1431 FRANKLIN STREET

Office Entitlement - Response to Design Review Analysis
11/09/2021

RESPONSES TO DESIGN REVIEW ANALYSIS

ARCHITECT'S ANSWERS TO NON-COMPLIANT AND UNCLEAR LINE ITEMS

LINE 16

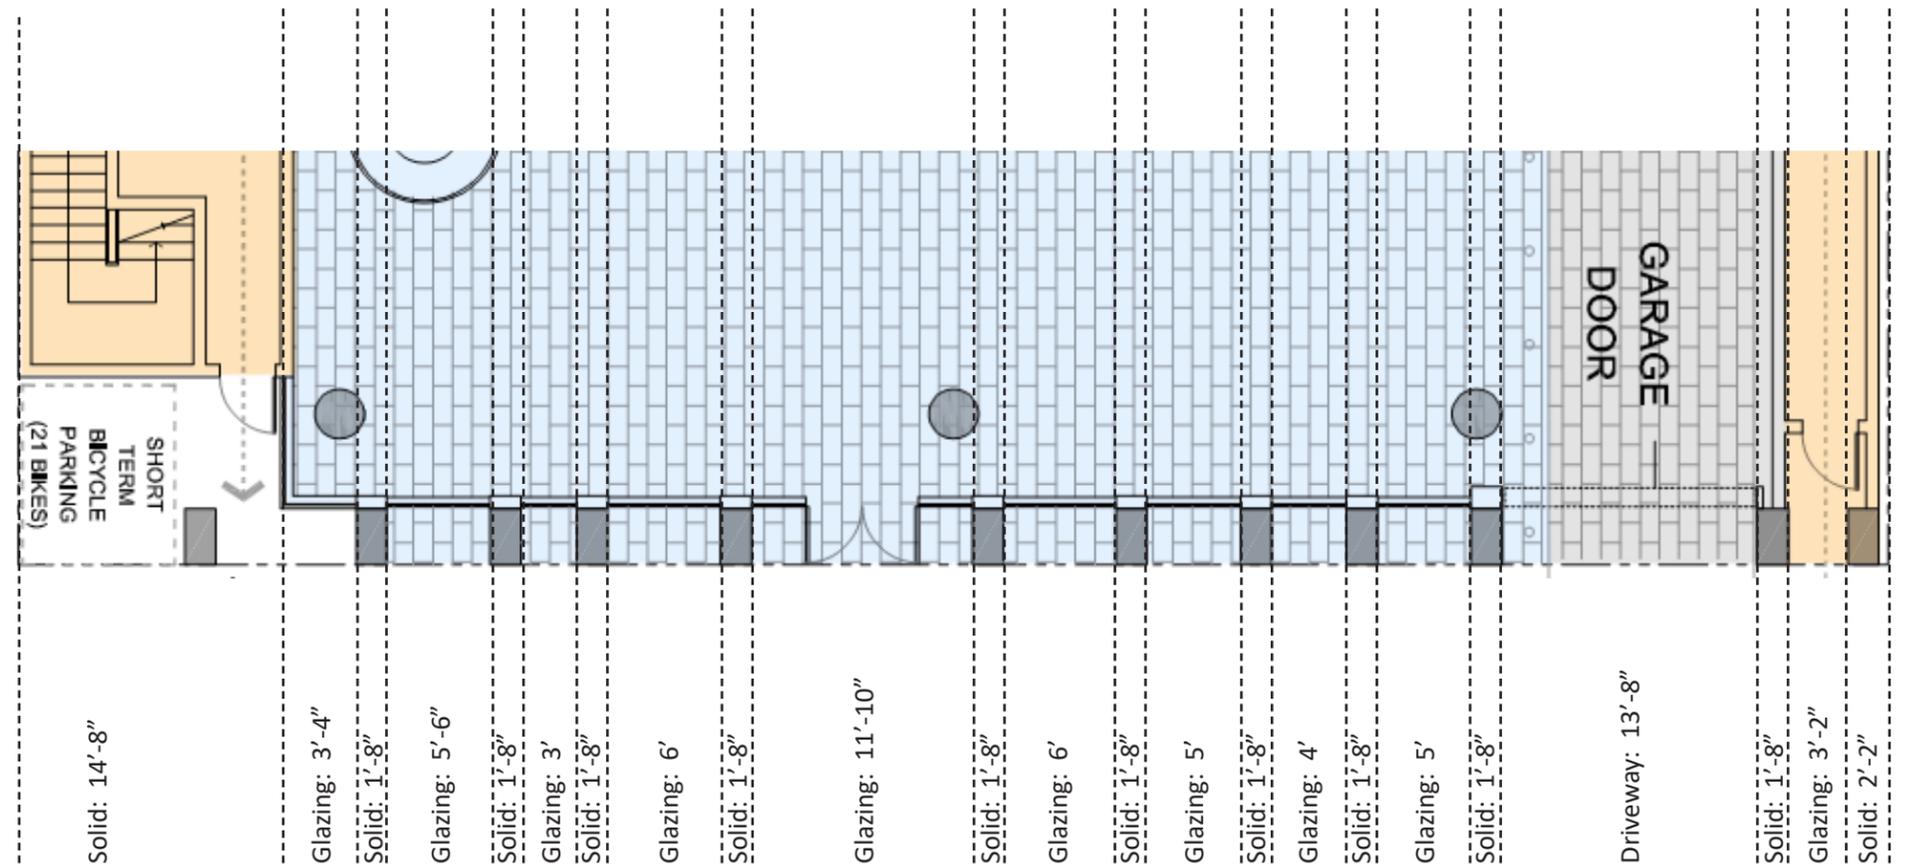
Without specific information, staff believes that the proposal meets this regulation.

The ground floor plan is shown below with the proposed elevation. The diagram illustrates the amount of transparency designed for the ground floor. At present the percentage is 66.5 percent. The minimum required transparency per the Oakland Chapter 17.58 - CBD Central Business District Zones Regulations is 65 percent.

→ Total Solid = 33'-6" = 33.5%

→ Total Transparent = 66'-6" = 66.5%

LINE 24

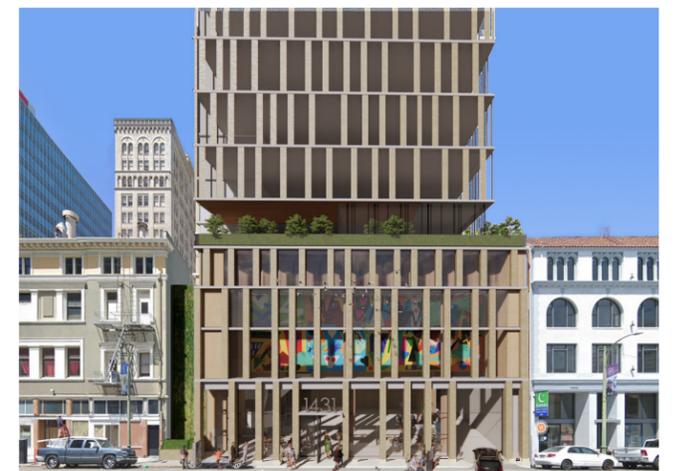
The box massing is being combined with “gradient pattern” that is less dense at the ground floor, with wider glazed windows and wide columns. Above the base the window widths become smaller in an almost random pattern. This should give the simple box shape of the tower the illusion of a reduction in mass as it rises, despite the fragmenting of the tower. Staff is concerned with the design and level of fenestration proposed and this affect on the API.

From there we adjusted the window openings to give the Piano Nobile slightly bigger openings. The difficulty there is that these levels are the parking levels which sets up a difficult problem. We want the windows to be open to the inside, but not have the vehicles visible to the exterior. The light needed to transfer into the building and out at night to give the building a sense of depth. The solution was to have a full height glass wall between the vertical columns of brick.

The proportion of the windows in the Piano Nobile zone have been widened for reasons noted above, but also given a rhythm that is more modulated than randomized. This gives the façade a direct relationship to the adjacent buildings. Moving upward, the zone more commonly referred to as the attic zone, in classical architecture, has a smaller more truncated proportion that relates both to Classical architecture, but also the adjacent buildings. The windows have been reduced in size and a cornice line has been introduced. We have also set the area above the attic zone back by ten feet and created a roof garden at that level to reinforce the podium datum that follows all along Franklin.

LINE 26

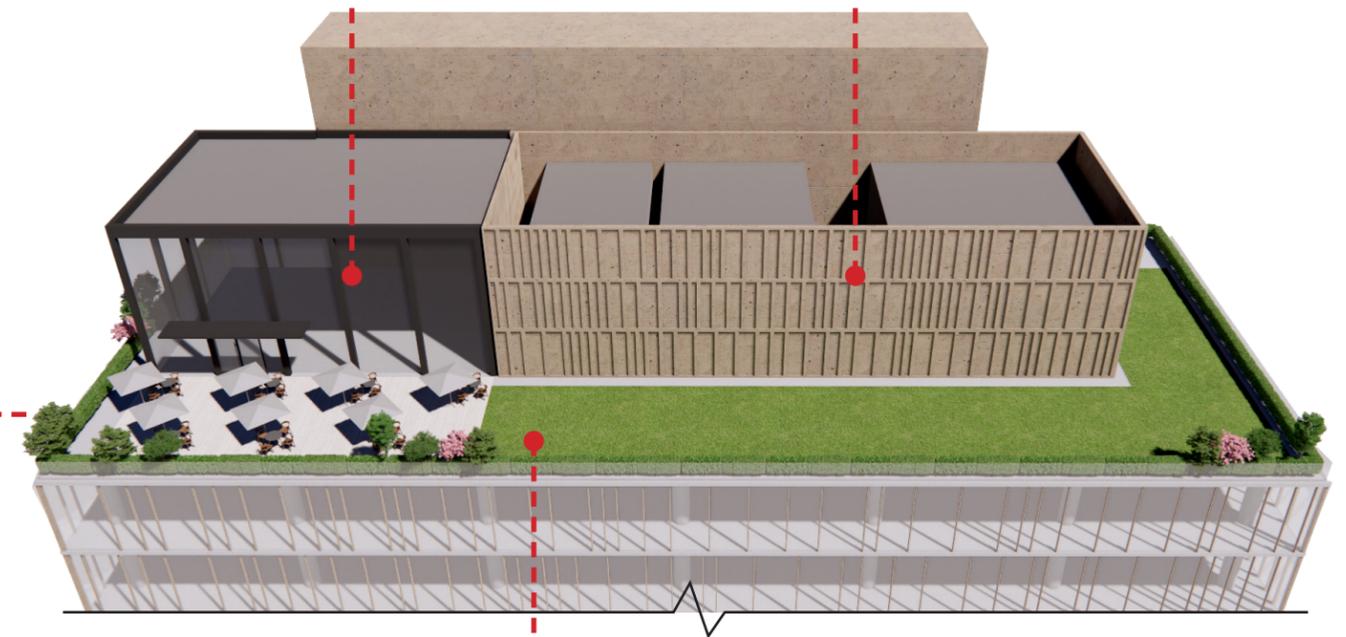
Although landscaping is proposed for the roof of the building, it is not yet clear whether mechanical equipment such as elevator tower or a/c equipment is being adequately screened or what mechanism would be used to screen such equipment.

The roof top design steps back to soften the truncated top of the building. The roof is also an amenity space for the office employees. The intention is to create a space that can either be a common office canteen, or café, or even recreation room. With the change in office culture due to Covid 19, employers are looking to create more flexible and diverse spaces that allow employees to feel more relaxed and safer.

Finned amenity space .

Mechanical area concealed with concrete textured relief.

LINE 42

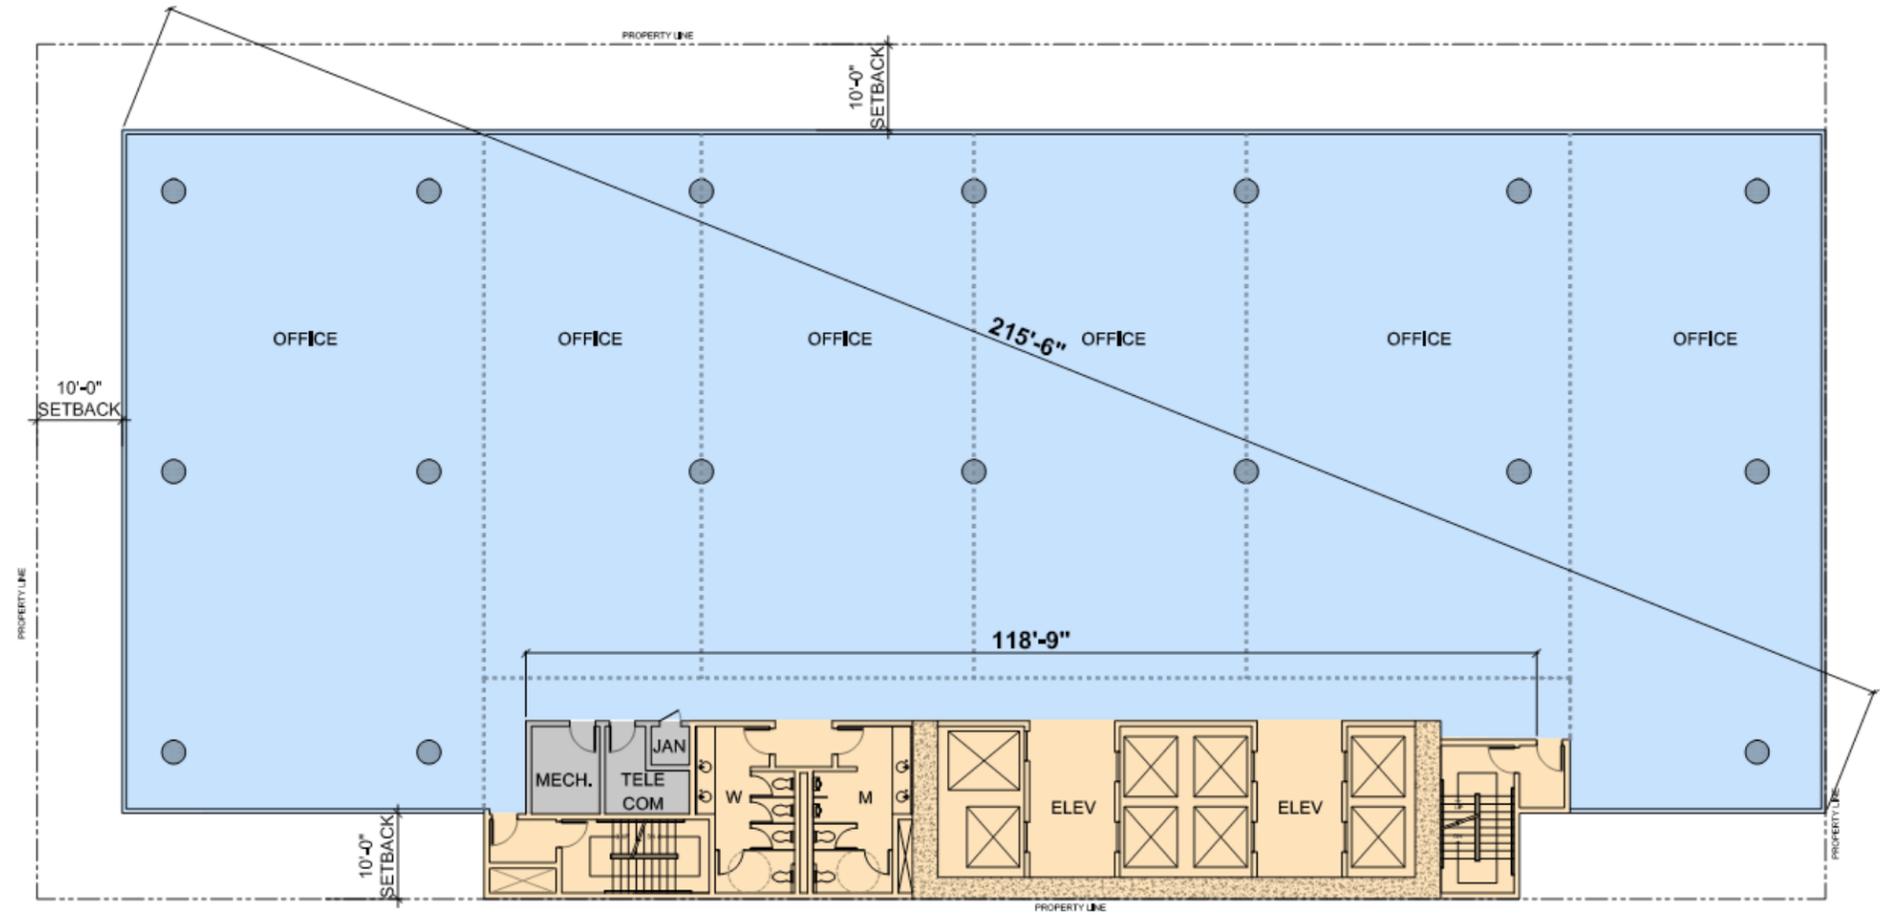
Discussion:
More information is needed.

Architect's comments:
Diagonal Length is 215'-6"

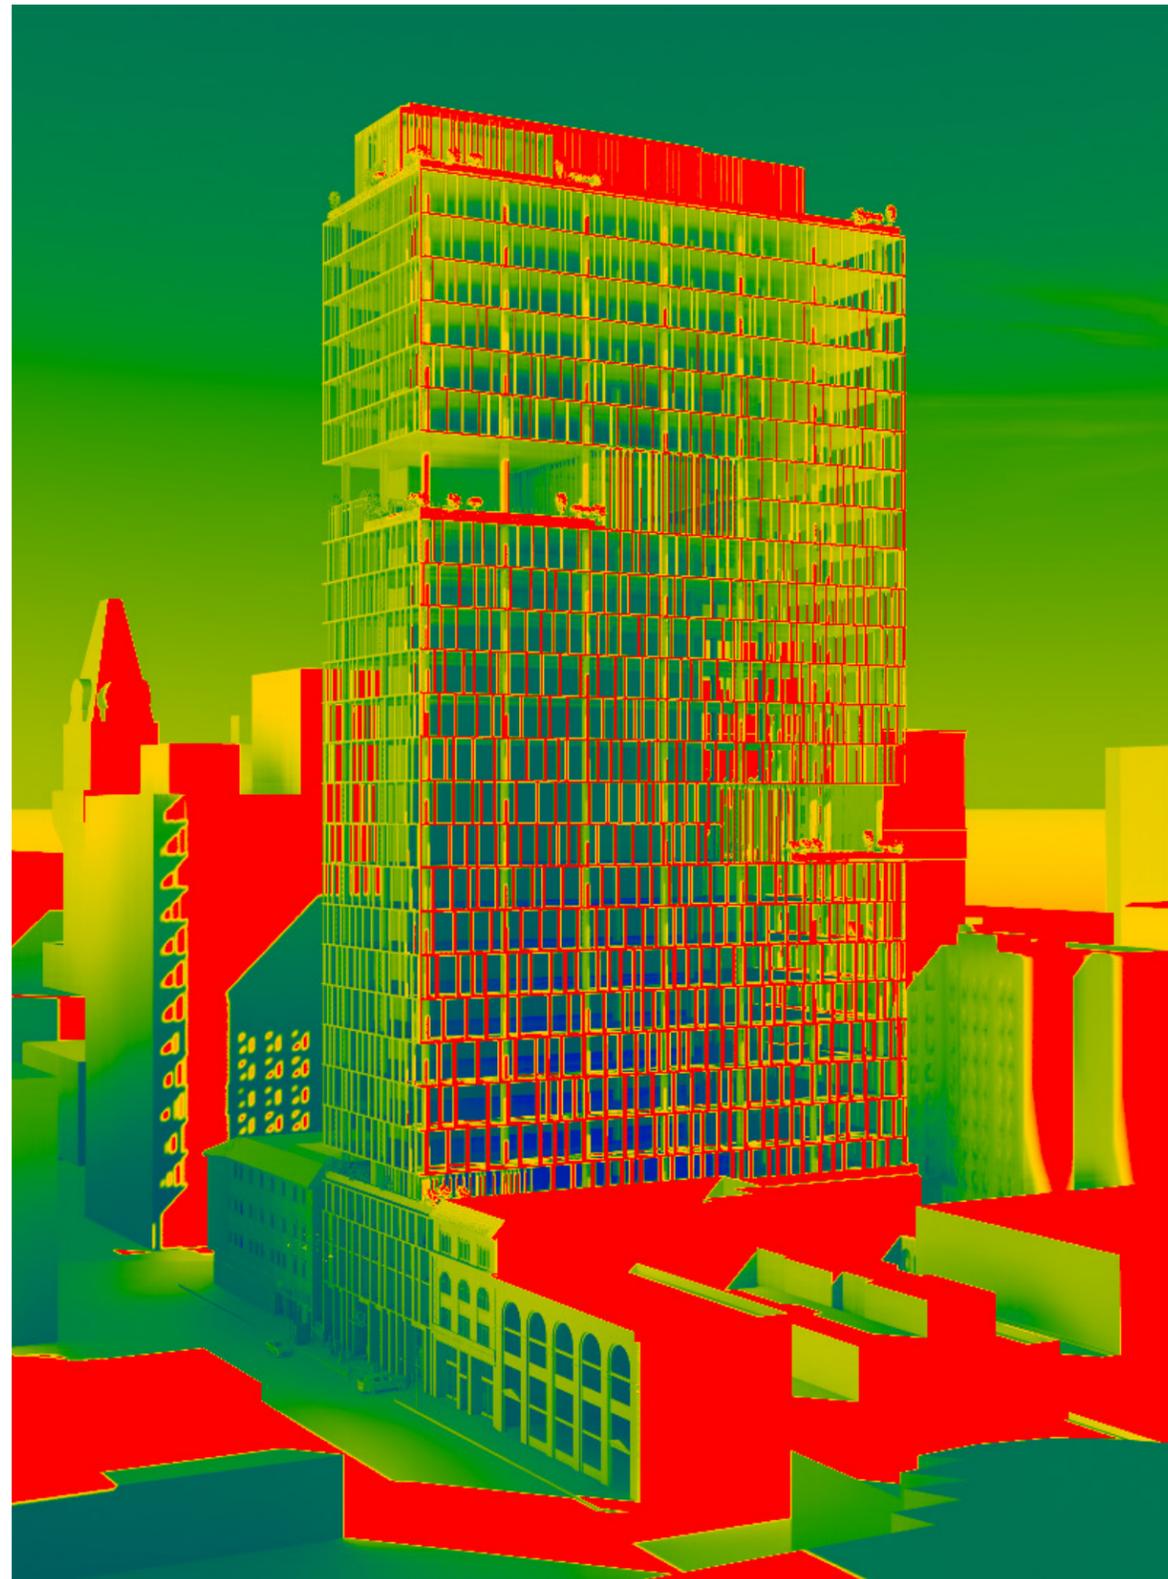
This new proposed design does not provide information on sustainable design techniques, on-site stormwater, or green building techniques.

The design of the exterior of the building will have very little to do with the real-life sustainable design techniques, on-site stormwater, or green building techniques. These are all items dealt with in great detail by Mechanical consultants during the Construction Document Phase.

LINE 78

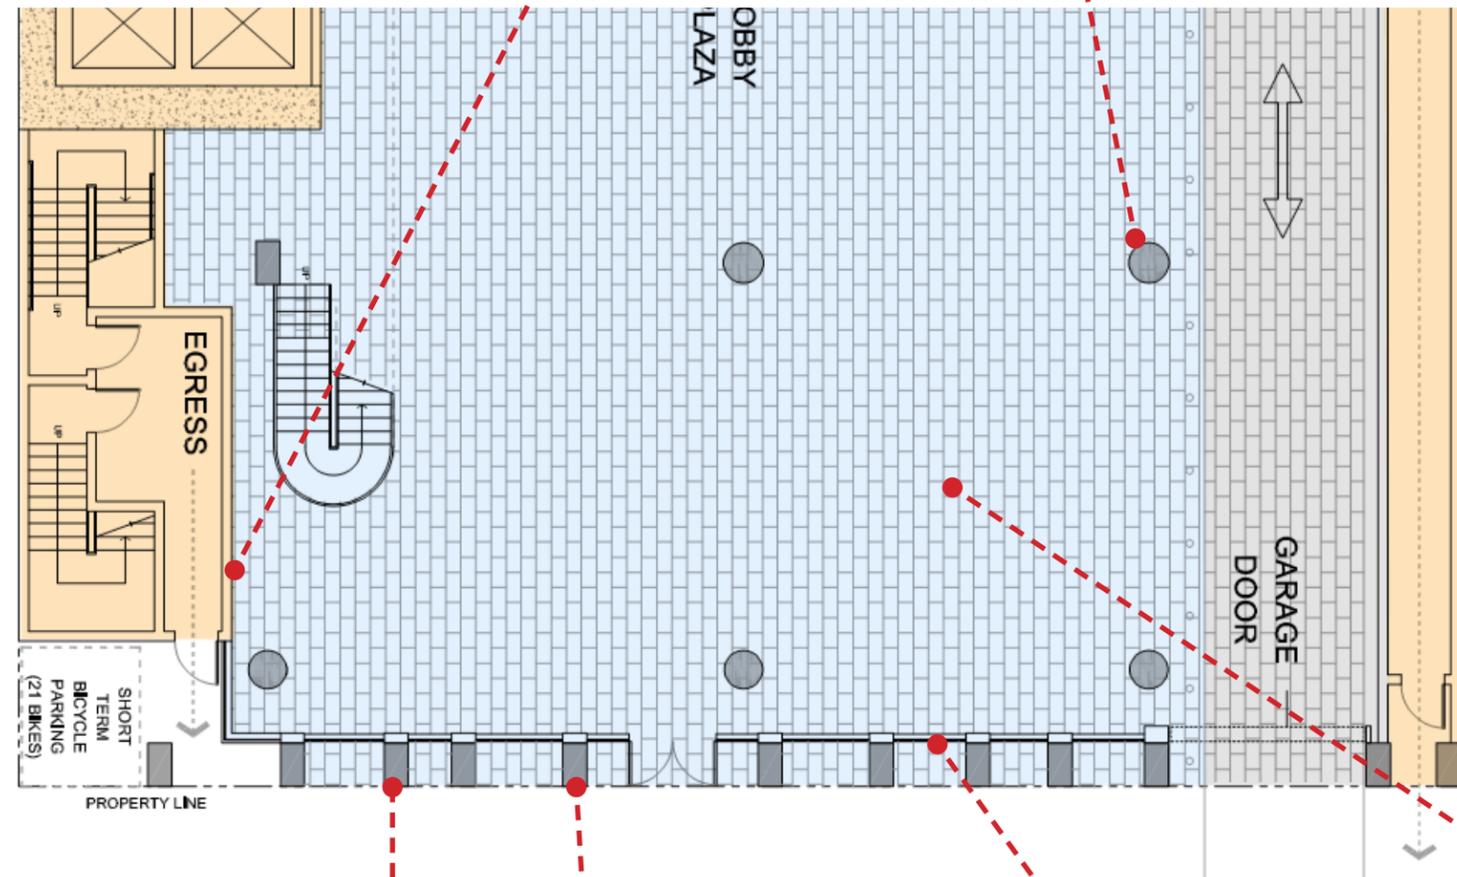
The plans provide general not specific dimensions for the lobby. More information on the columns/pillars, materials of design, proposed activity (if any) would be located at the ground level.

The proposed design is for an office building, not a commercial space. This does not seem to apply to our project. Below is a plan showing the specifics of the lobby and the finishes.

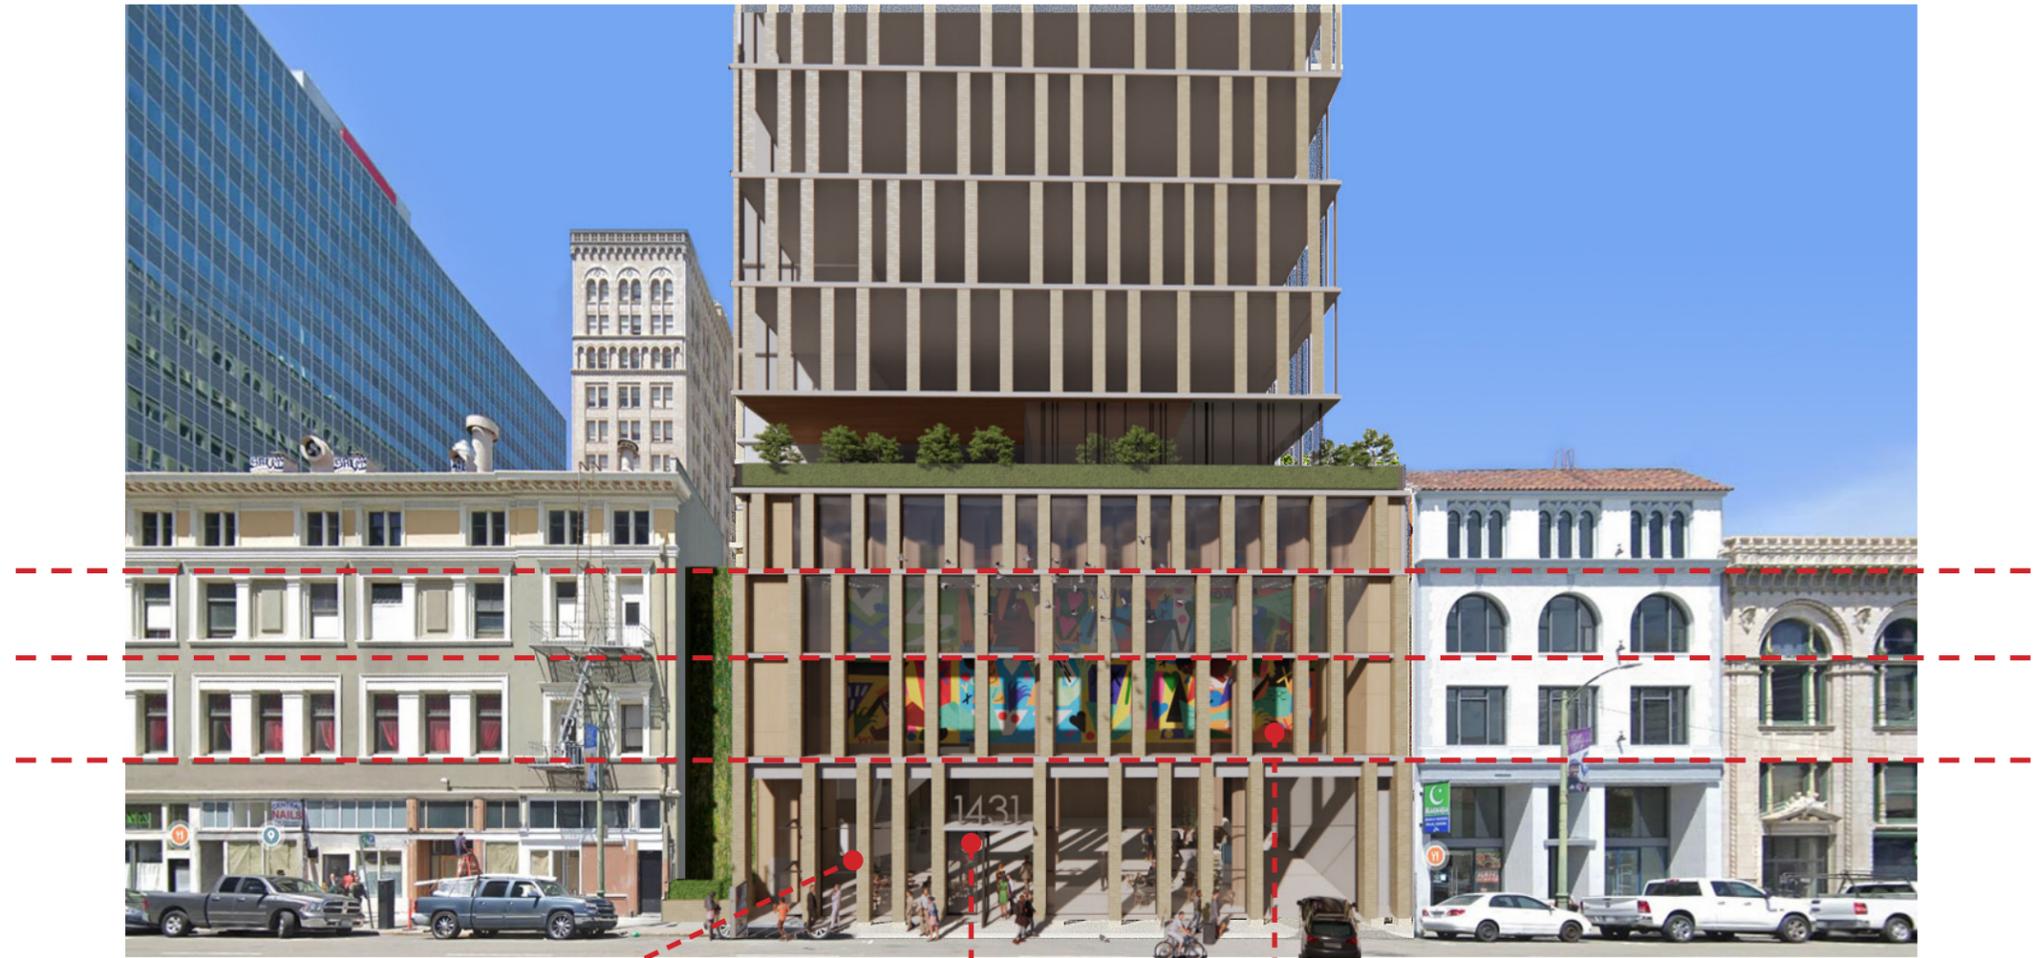
The height of the floor levels of the base relate to the horizontal details of the adjacent buildings, but box design of the building and the “gradient pattern” with wider glazed windows and wide columns at ground level is in contrast to buildings in the API. Staff is concerned with the challenge of maintaining high quality materials for the proposed fenestration and an adverse effect on the API.

The revised design has adjusted the floor levels of the base to relate to the horizontal details of the adjacent buildings. The windows at the base have been widened to open up the lobby and to coordinate with the adjacent buildings and the API.
